AFHP Design # 560.121 RL
 308-2010 Wendy Welton 603.431.9556
Laughing Daffodil Sun
 1 of 8 Rockingham Green

Lot 1: 6.2.2014 - Lot Change

Lot 8 Rockingham Green Newmarket, NH	14-21-07 unless noted otherwise / P/ton @ 1:1 PDF created on: 6/22/2014, drawn by ACI	Revised Cans
R1: 6.2.2014 - Lot Change

Rear Elevation

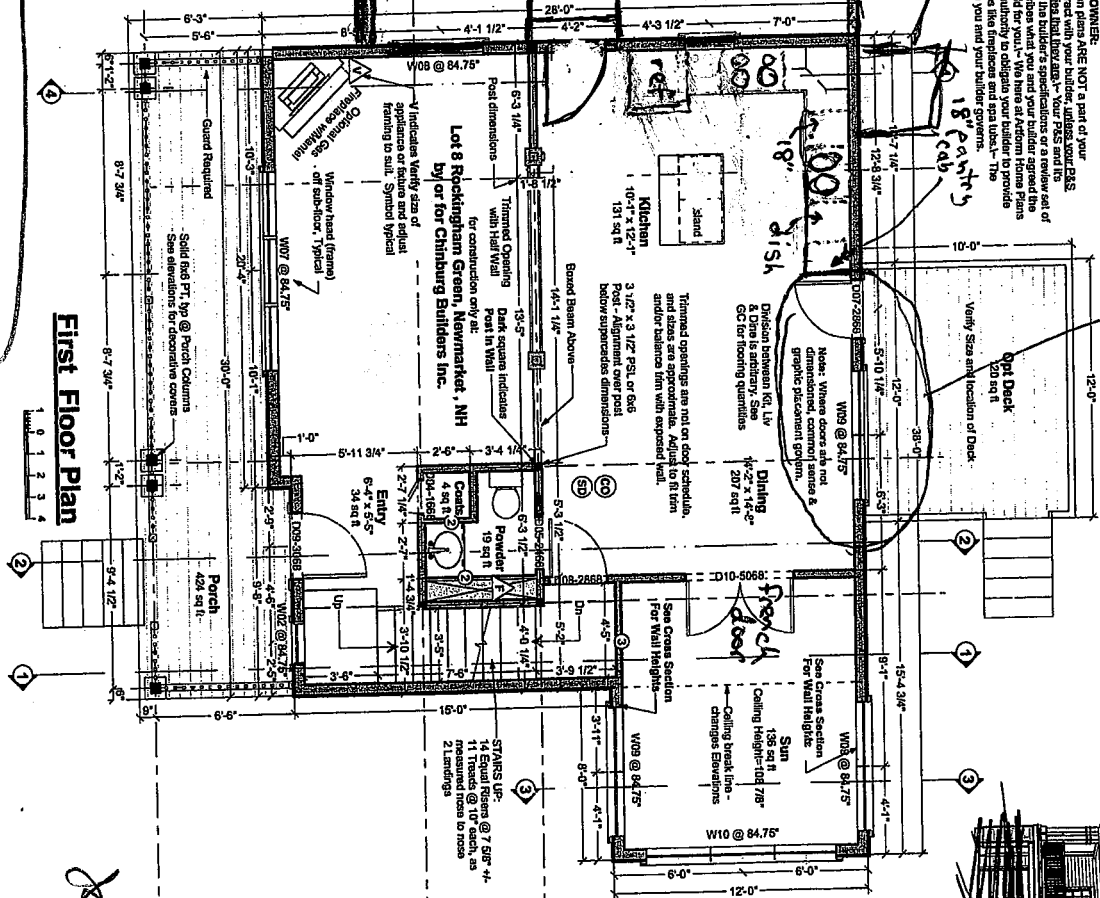
slider door + windows
~ 6" x 12" to right
